### **TUALATIN ARCHITECTURAL REVIEW BOARD**

**April 9, 2014, 7:00 PM**

- A. Southwest Industrial Park Recommendation and Staff Report for AR-14-02

**C2.2A**

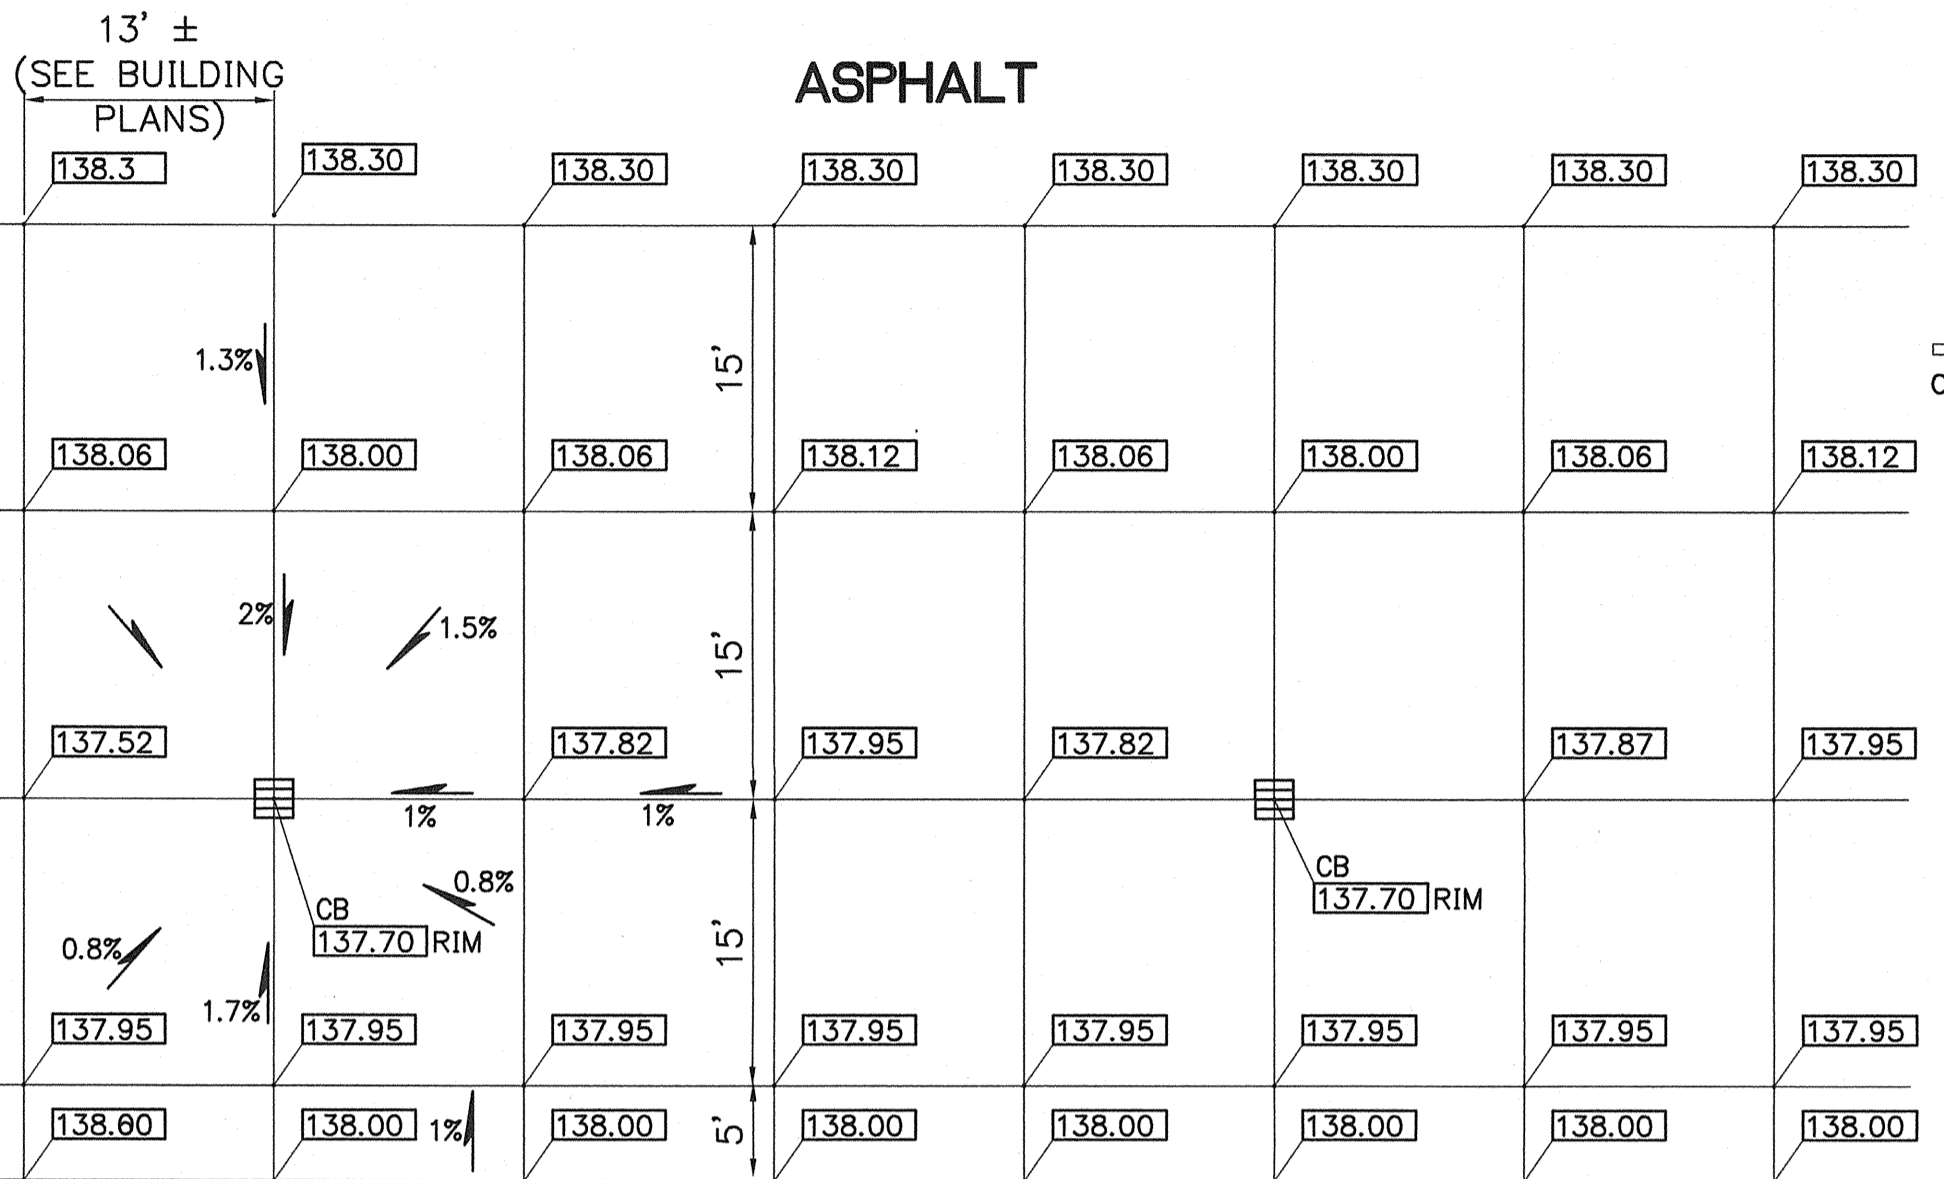
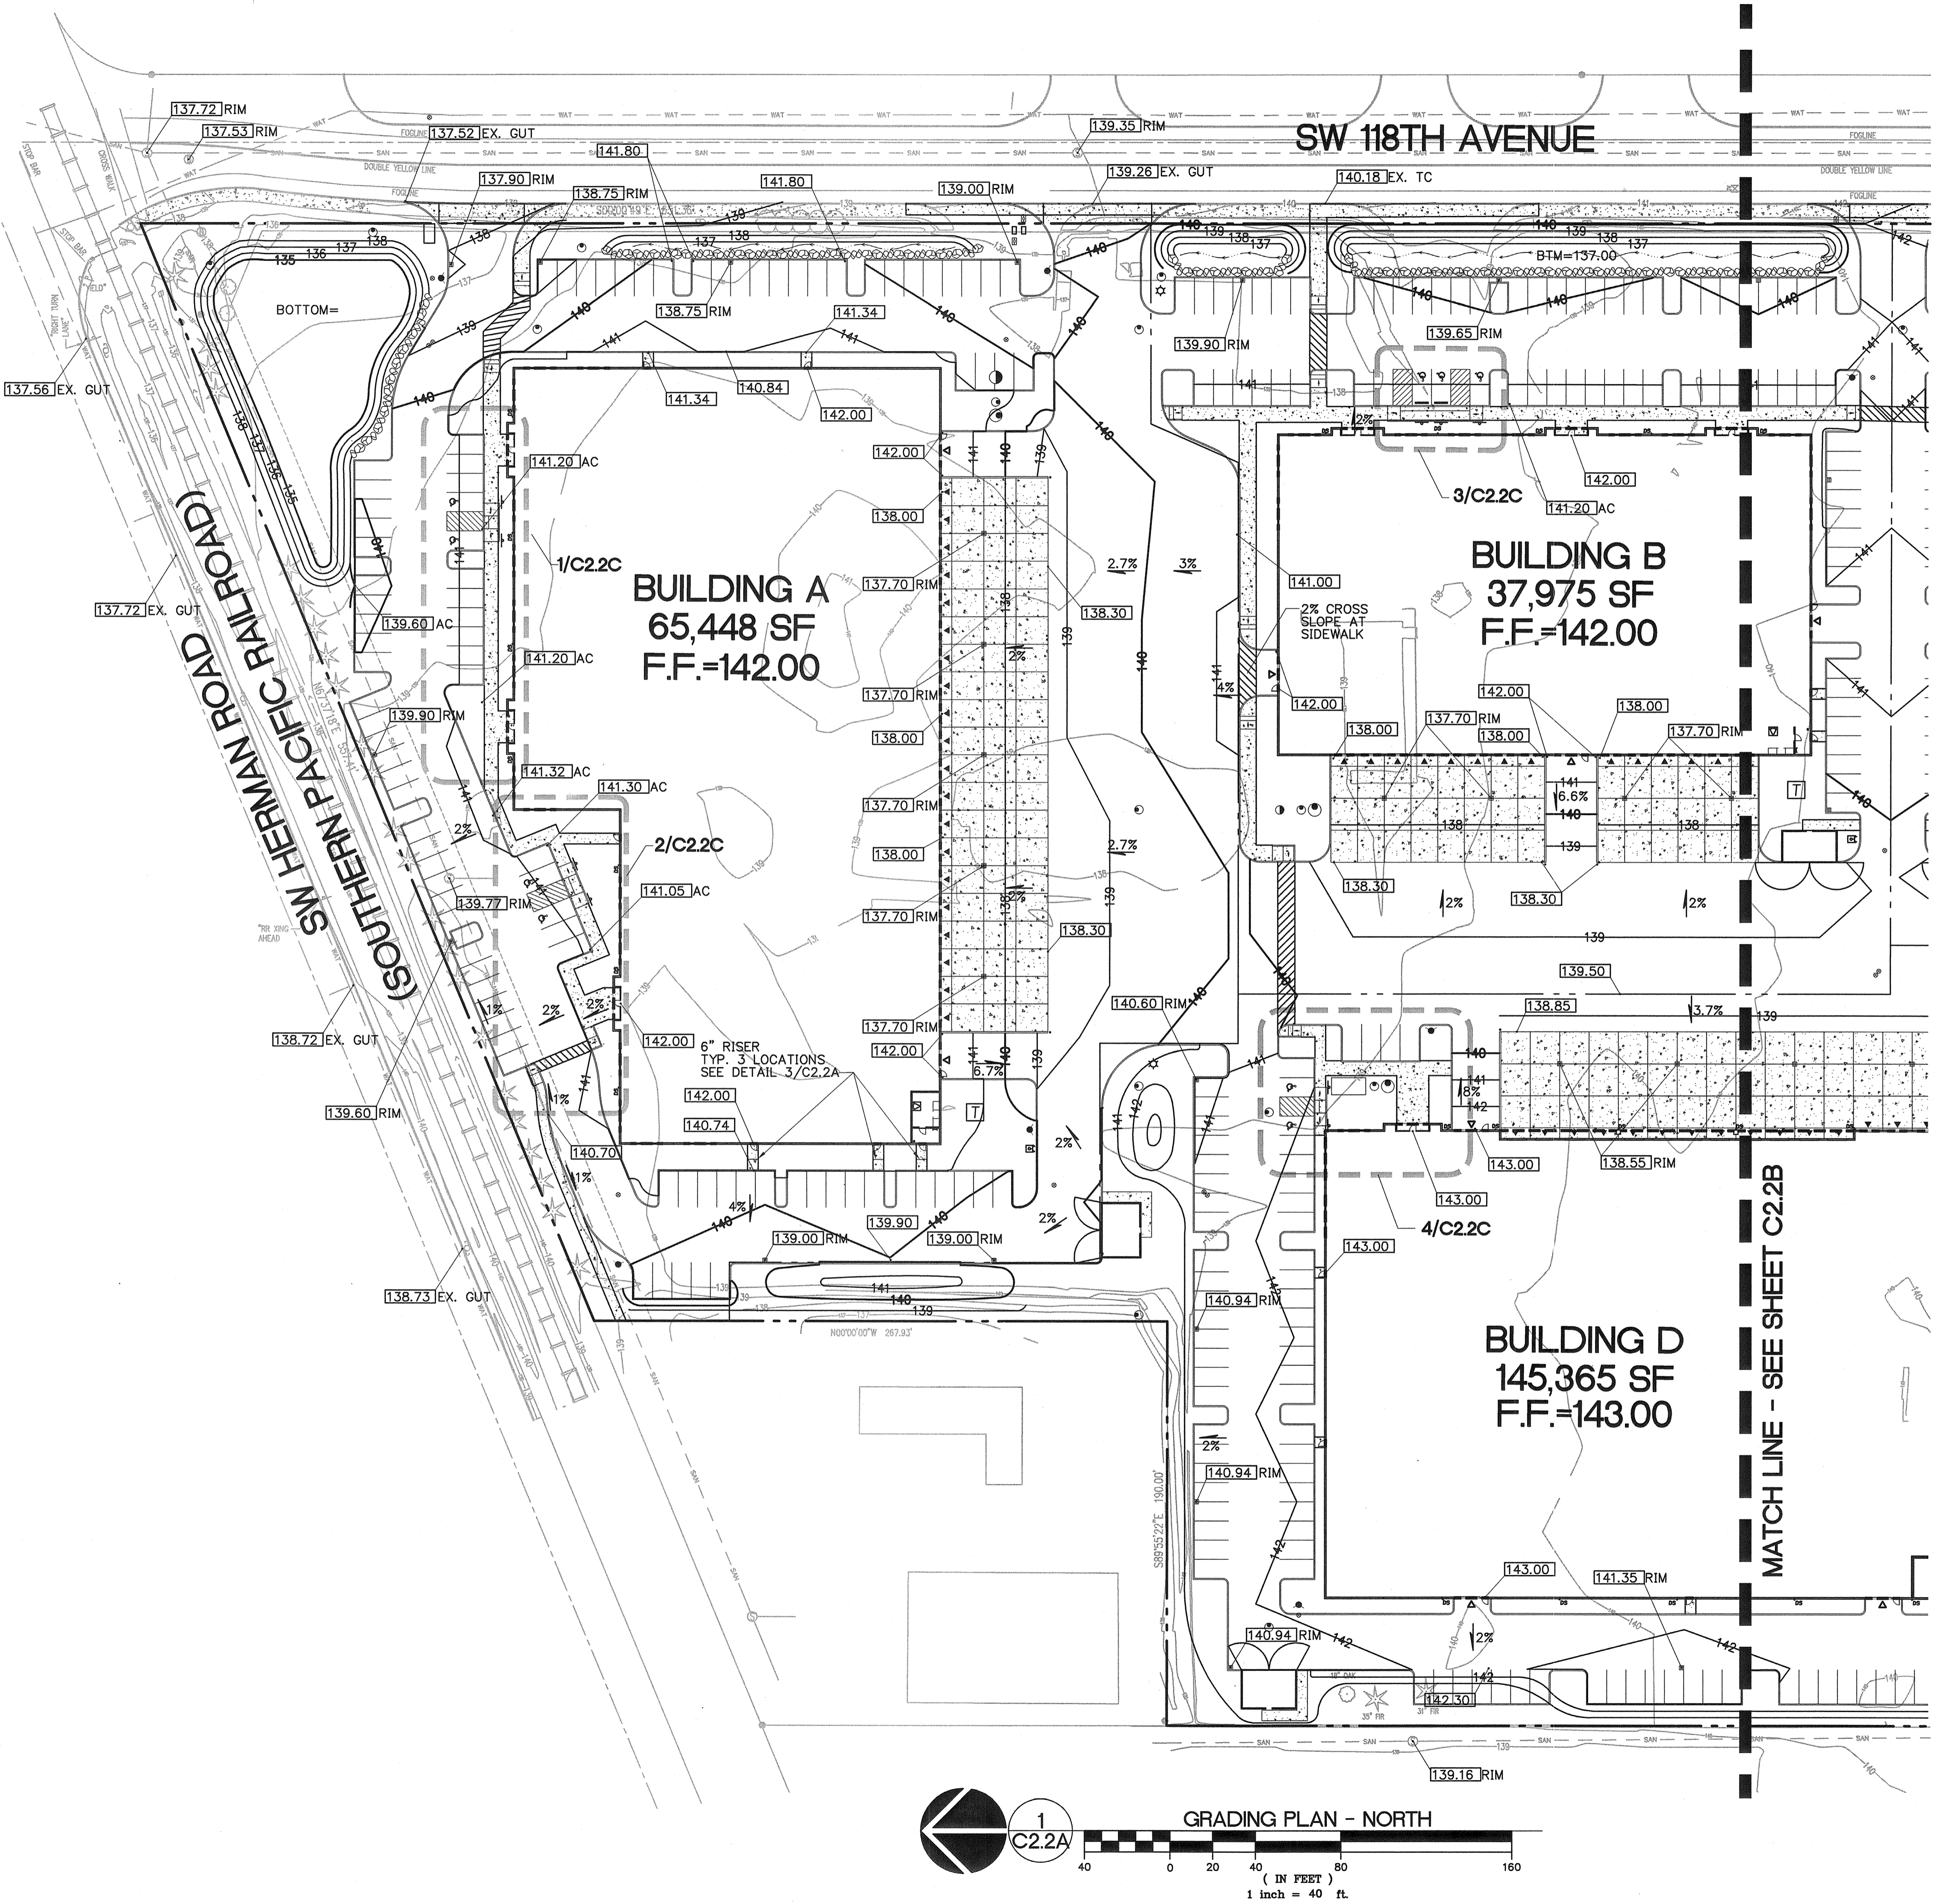
The grading plans (Sheets C2.2A and C2.2B) show that the drainage system directs stormwater away from walkways, buildings and landscape areas that are not WQFs, meeting the requirement.

## SITE PHOTOMETRIC

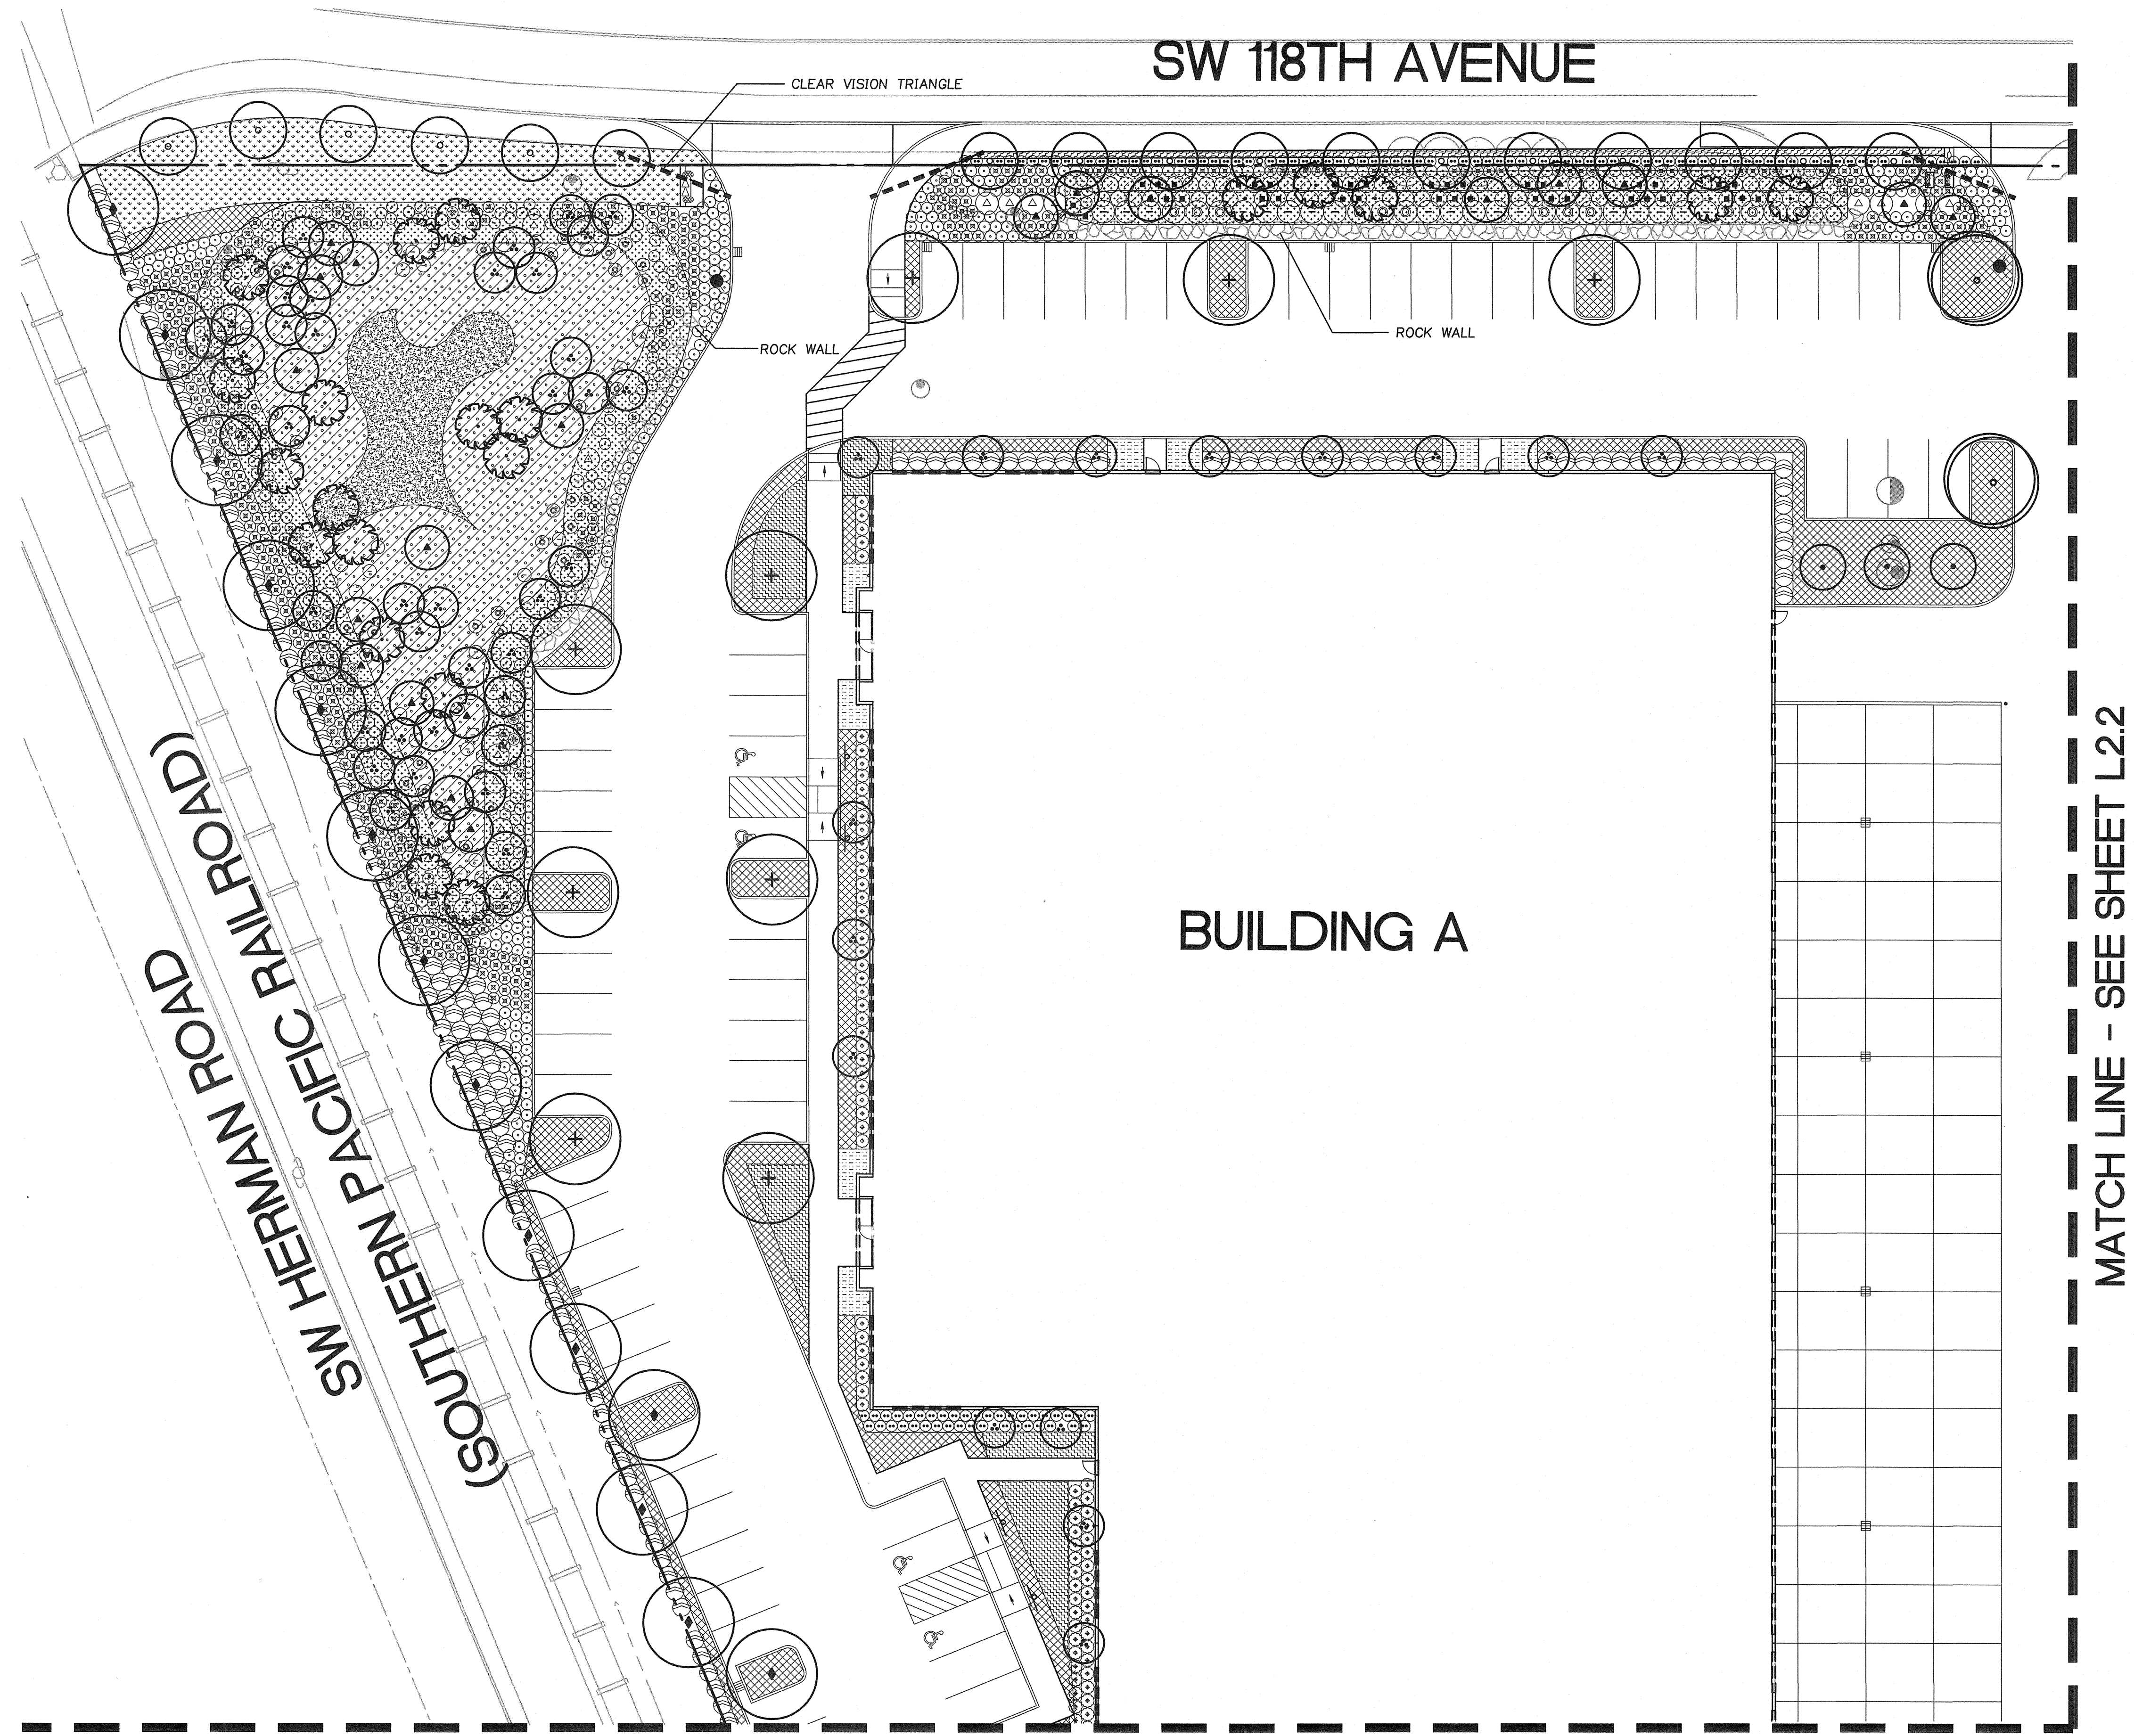
The site photometric plan (Sheet ES 0.01) illustrates that exterior fixtures light the site such that they facilitate surveillance of on-site activities from the public ROW, meeting the requirement.

Regarding (6), for exterior pole-mounted lighting the application materials include technical specification cut sheets. The site photometric plan (Sheet ES 0.01), i.e. the lighting plan, illustrates two light poles along the site edge, one near the northeast corner of Building B 16 ft from SW 118<sup>th</sup> Avenue and one near the southwest corner of Building C 11 ft from SW Myslony Street. The light levels close to the avenue and the street would be respectively 6.1 and 4.2 footcandles (fc). The *Guidelines for Good Exterior Lighting Plans* (Attachment 110) include the recommendation that light levels at a business property line should not exceed 0.1 (fc). Because the application materials imply that pole-mounted lighting might shine or create glare on the avenue or street ROW, the applicant needs to provide revise plans or provide “cut sheets” to show that light levels at SW 118<sup>th</sup> Avenue and SW Myslony Street should not exceed 0.1 (fc).
